TRANS/WP.29/GRSP/2000/10
11 August 2000

World Forum for Harmonization of Vehicle Regulations (WP.29)

PROPOSAL FOR DRAFT AMENDMENTS TO REGULATION No. 14
(Safety-belt anchorage)

Transmitted by the Expert from Spain

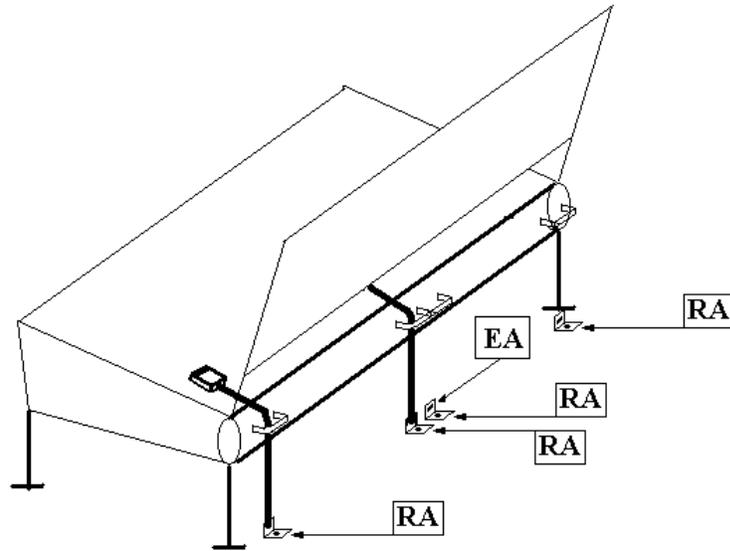
3. In the annexed drawing, there is an example: a seat bench for two people, where lower anchorages are fixed to the floor. Their buckle is supported by a belt or a flexible cable.

- In this case, the effective anchorage (EA) is located on the guide where the belt passes through the metallic element fixing the belt to the floor.
 - The angle (b) from the horizontal is measured according to Regulation No. 14, but the belt itself does not follow that line, because it passes over the seat transversal structure, and the real belt angle from the horizontal is (a).

- In consequence, the current definition of the effective anchorage may not be used to verify the belt angle ("b" is much bigger than "a"). A change in the definition is needed.

Adoption of the proposal, would provide a new effective anchorage (PEA). It could be seen that using the proposed definition, the angle formed by the belt is approximately the same as the angle formed by line "R-PEA".

Paragraph 2.4., amend to read:

"2.4. "Effective anchorage" is the latest rigid part of the vehicle, seat or anchorage, contacted by the flexible or adjustable part of the safety-belt, when adapted to the user's morphology. It does not necessarily correspond to the real anchorage"
